**SECTION 00 9111
ADDENDUM NUMBER 1**

DATE: MAY 4, 2015

PROJECT: CAPE MAY CORRECTIONAL FACILITY

PROJECT NUMBER: 13-2200-0241

SD-A101

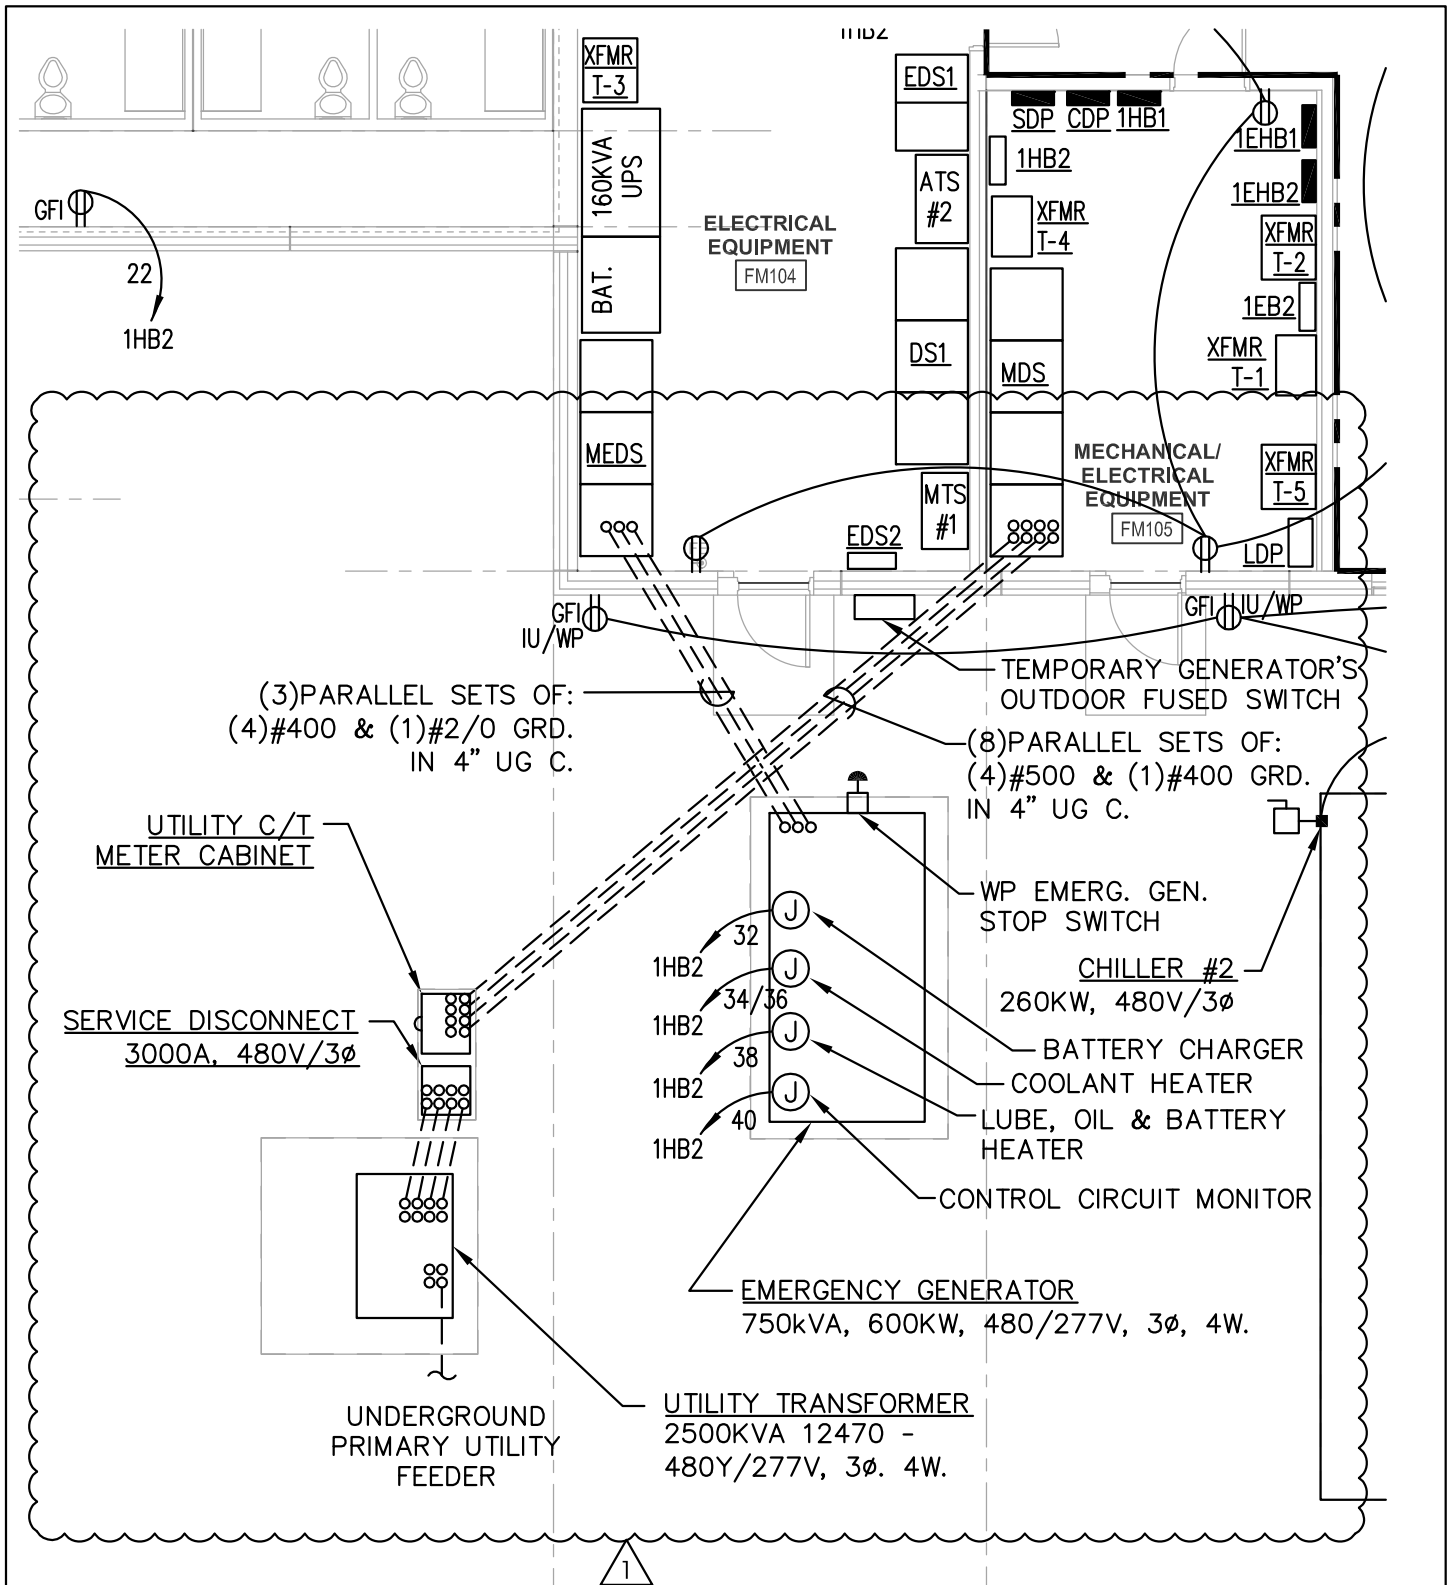
DRAWING A111A - FIRST FLOOR PLAN - AREA A

Item #15. Revise Drawing according to Supplemental Drawing SD-A101 issued with this addendum.

A TYPICAL PLAN DETAIL AT EXTERIOR PRECAST WALL CORNER
 1 1/2" = 1'-0"

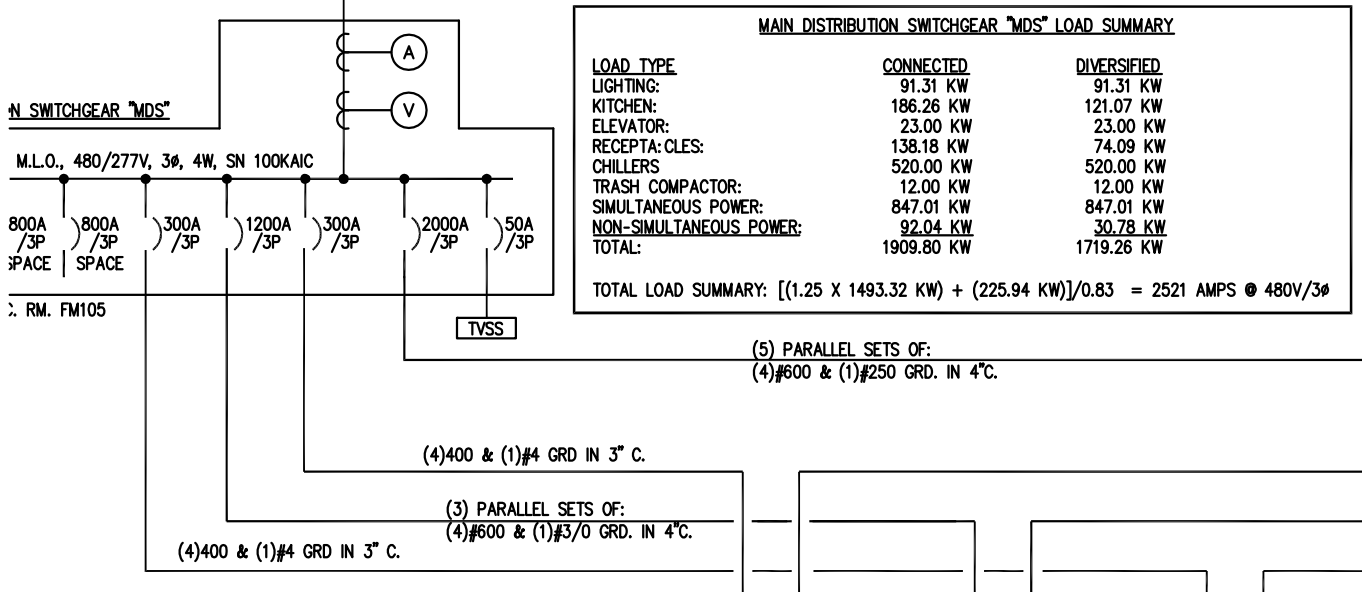
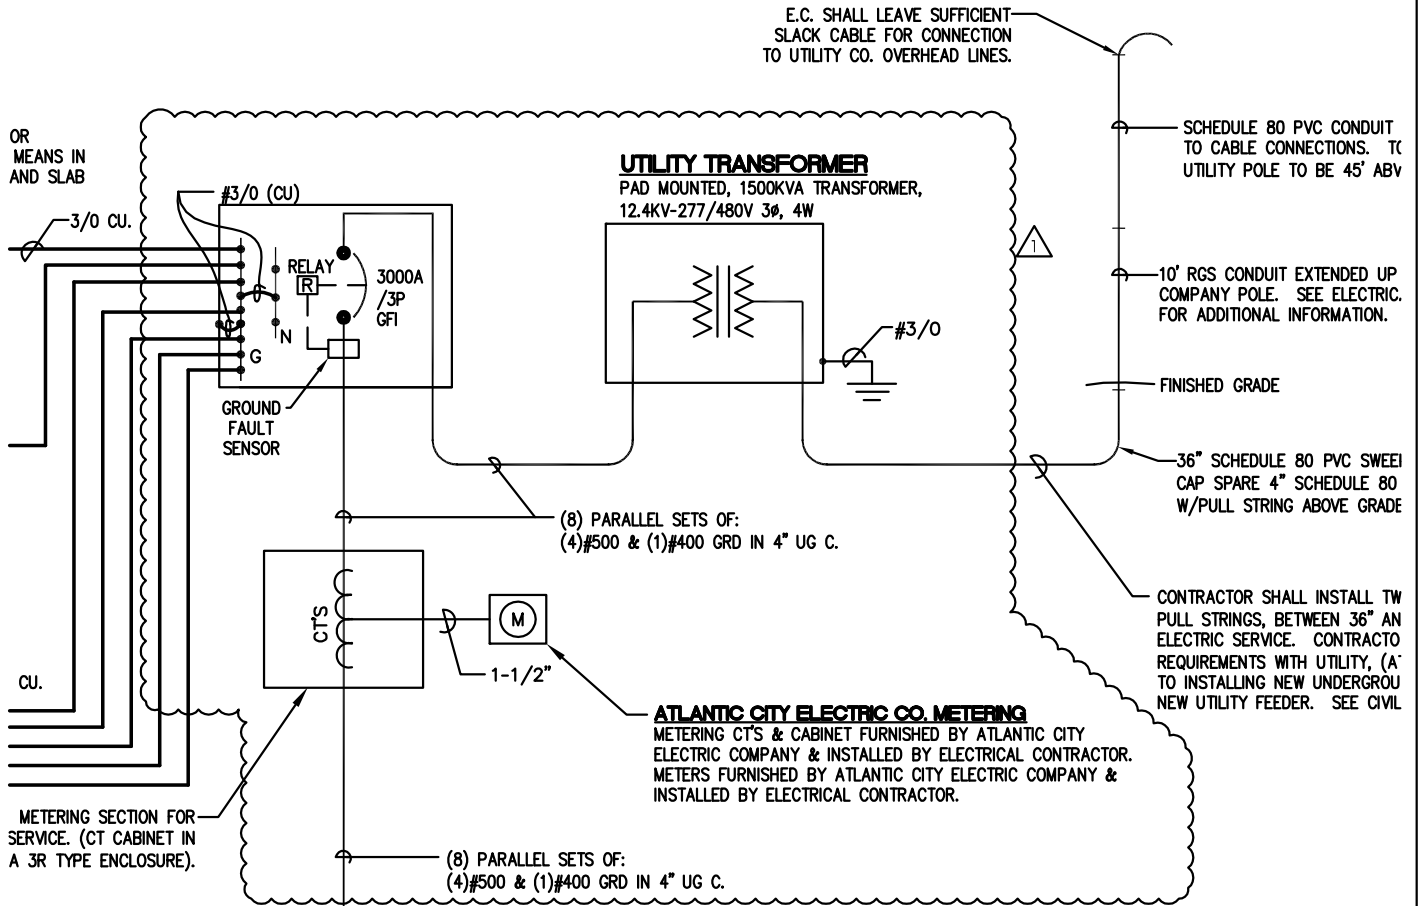
DRAWING E211B - ELECTRICAL RECEPTACLE POWER FIRST FLOOR AREA PLAN - AREA B

Item #23. Revise drawing according to Supplemental Drawing SD-E101 issued with this addendum.

PARTIAL POWER PLAN - AREA B

(REVISED DRAWING E211B)

SUPPLEMENTAL DWG
SD-E102

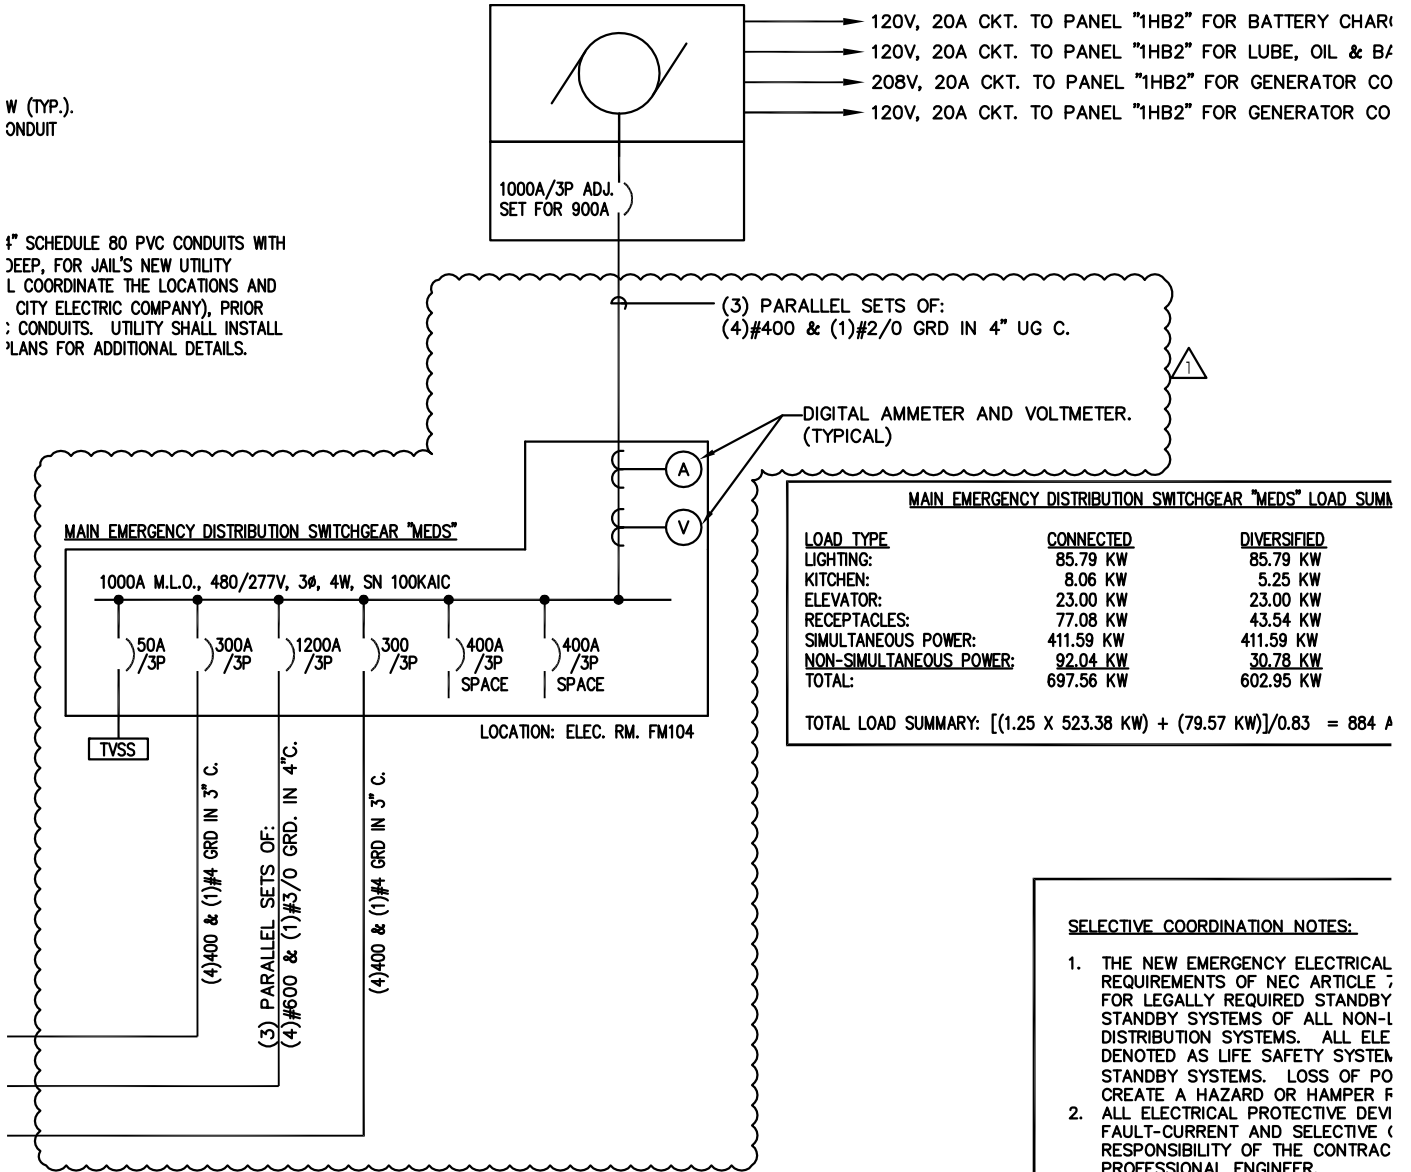
DRAWING E501 - ELECTRICAL SINGLE LINE DIAGRAM

Item #24. Revise drawing according to Supplemental Drawing SD-E102 issued with this addendum.

PARTIAL SINGLE LINE DIAGRAM

(REVISED DRAWING E501)

SUPPLEMENTAL DWG
SD-E103

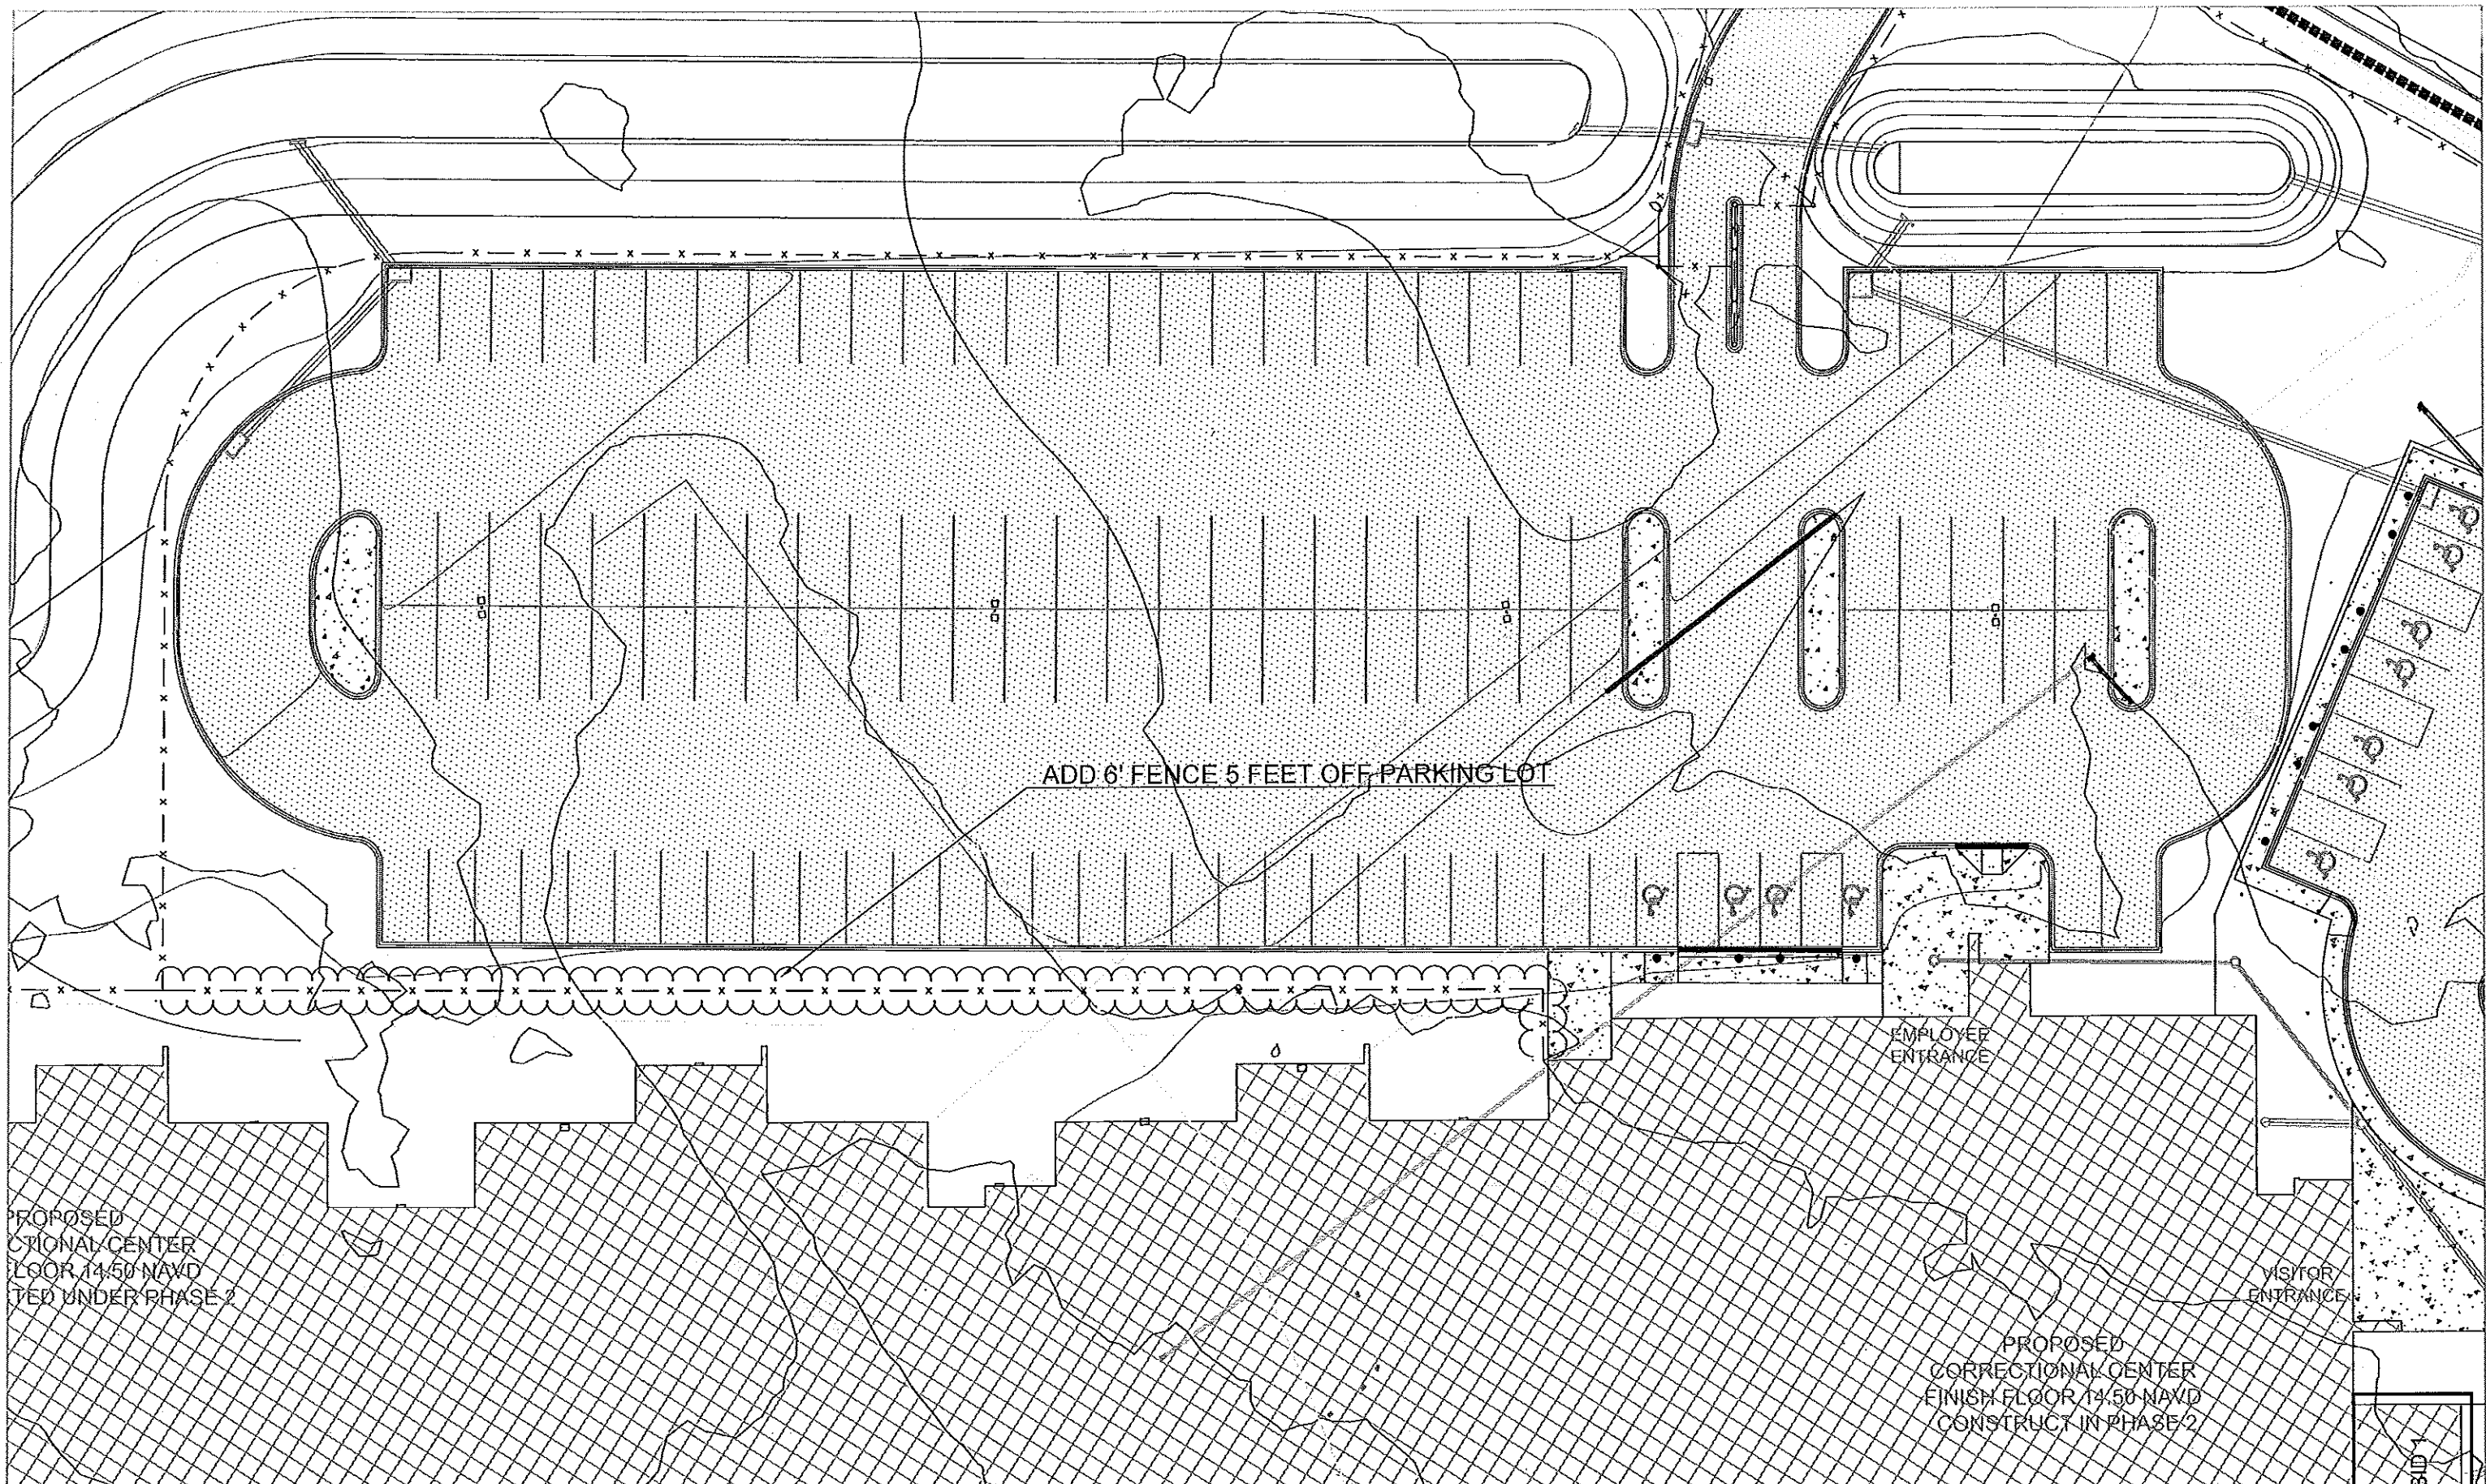
Item #25. Revise drawing according to Supplemental Drawing SD-E103 issued with this addendum.

GENERAC MODEL MB600, (OR APPROVED EQUAL), OUTDOOR, BI-FUEL, (NATURAL GAS/DIESEL), 750KVA, 600KW, 903A, 480/277V, 3Ø, 4W, EMERGENCY GENERATOR, (UL2200 LISTED), WITH A 1000A/3P ELECTRONIC ADJUSTABLE MAIN CIRCUIT BREAKER SET FOR 900A. PROVIDE WITH A SKID-MOUNTED INTEGRAL 2002 GALLON DIESEL FUEL TANK AND LEVEL 2 ALUMINUM ENCLOSURE WITH CRITICAL GRADE SILENCER. PROVIDE GENERATOR WITH MANUFACTURER'S OPTIONAL 832KW UP-SIZED ALTERNATOR. SEE SPECIFICATION SECTION 263212 - "BIFUEL ENGINE GENERATOR" FOR ADDITIONAL INFORMATION.

1. THE NEW EMERGENCY ELECTRICAL REQUIREMENTS OF NEC ARTICLE 708 FOR LEGALLY REQUIRED STANDBY SYSTEMS OF ALL NON-LIFE SAFETY SYSTEMS. ALL LIFE SAFETY SYSTEMS SHALL BE DENOTED AS LIFE SAFETY SYSTEMS. LOSS OF POWER TO LIFE SAFETY SYSTEMS SHALL BE PROHIBITED.
2. ALL ELECTRICAL PROTECTIVE DEVICES SHALL BE PROVIDED AND SELECTIVE COORDINATION SHALL BE THE RESPONSIBILITY OF THE CONTRACTOR AND PROFESSIONAL ENGINEER.
3. COORDINATION STUDY AND REPORT SHALL BE PROVIDED.
